Engineering Change Order 0409 – Jockey Wheel Shaft & Brake Disc

Applies from Serial Number 2190300 (US), 1190311 (AU)

Date of Change January 2019

1610-11-70

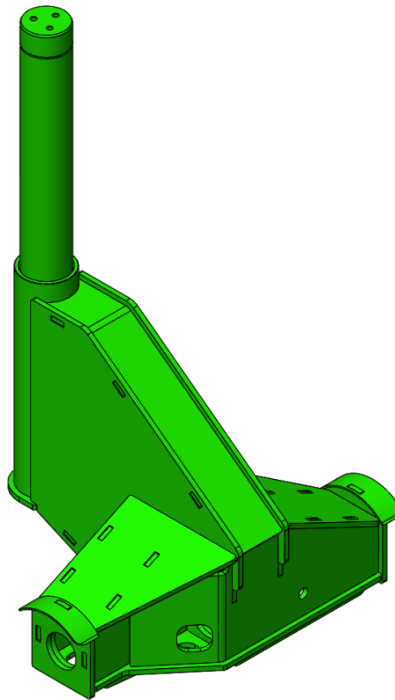
- Change made to jockey wheel shaft to allow for bolt on brake disc
- Brake disc lock (0801-LOCK01-35) deleted from fastener kits
- New shaft part number 1601-12-70 created
- New assembly 1610-11-70A created for spare parts (includes jockey wheel, brake disc, bolts, circlip)

Replaces:	1601-11-70 shaft, 0800-02.1 brake disc, 0801-LOCK01-35, dust cap 0801-KE705-13/C
Machines Affected:	9m, 12m, Model 46
Assembly Manuals Changed	Y
Technical Bulletin	n/a
